## T10/04-023 revision 0

From: George Penokie (IBM/Tivoli)

Subject: SAM-3: Converting to UML part 1

Figure 4 — Logical unit class diagram

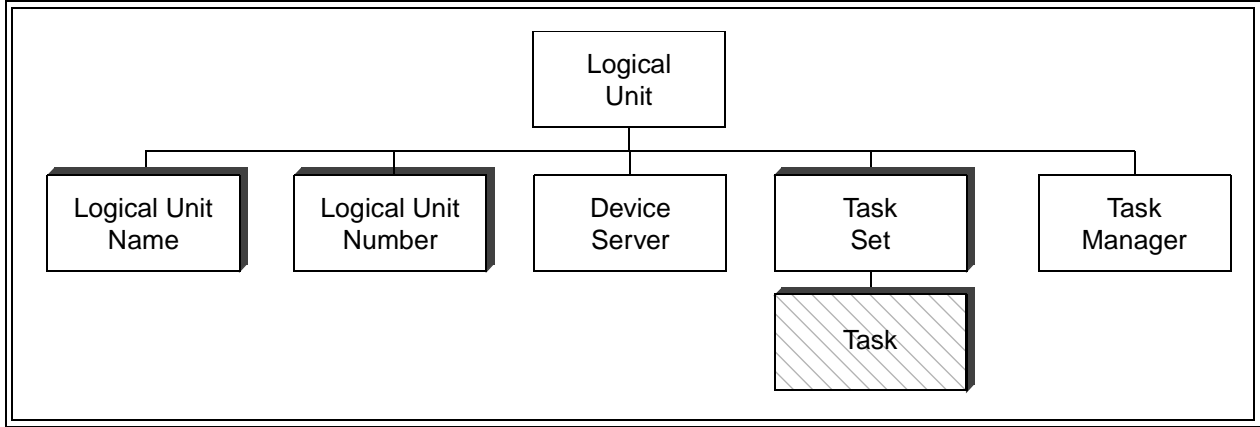
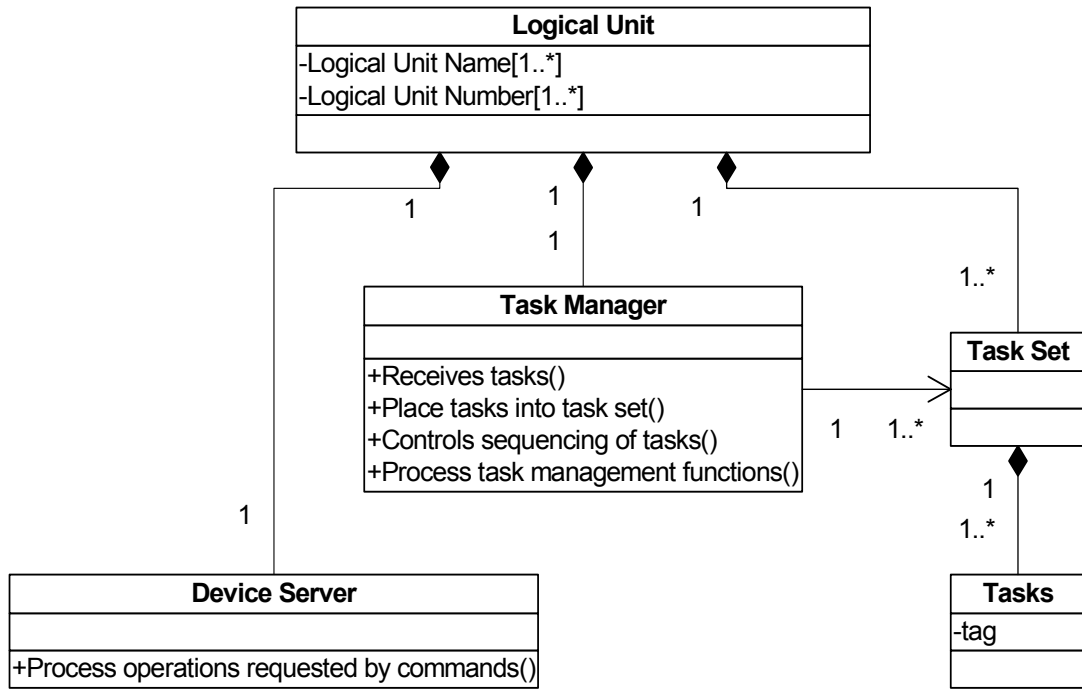
For an example of what figures in SAM-3 would look like a converted logical unit model (see figure 3) as currently shown in SAM-3 would look like what is shown in figure 4.

Figure 1 — Example hierarchy diagram

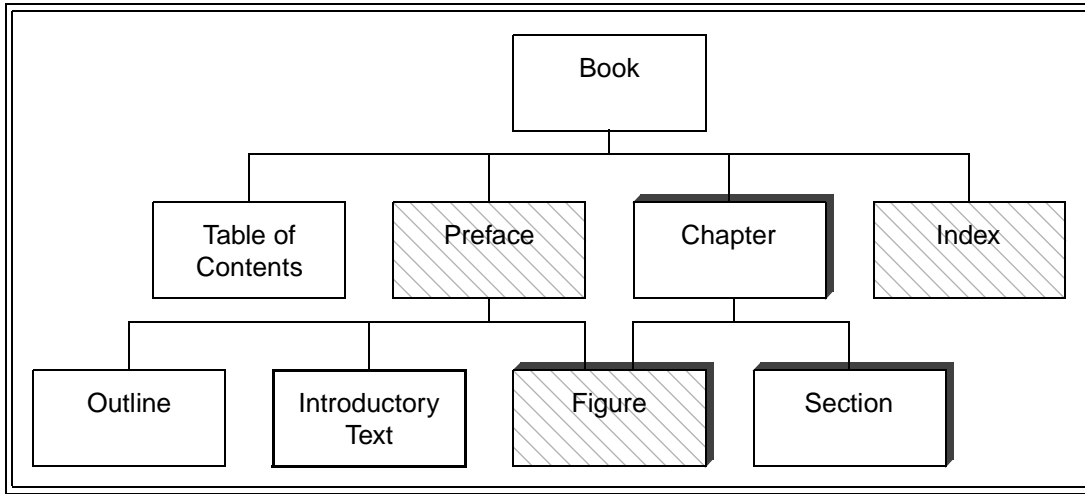
### 2.6.1 ~~Hierarchy~~Class diagram conventions

~~Hierarchy diagrams show how objects are related to each other. The hierarchy diagram of figure 1, for example, shows the relationships among the objects comprising an object called Book. For this example, a book object is defined as containing a table of contents object, an optional preface object, one or more chapter objects, and an optional index object. Further contents definitions are provided for the preface and chapter~~

[The notation in this subclause is based on the Unified Modeling Language \(UML\) specification.](#)

[Figure 2 shows the notation used for classes in class diagrams.](#)
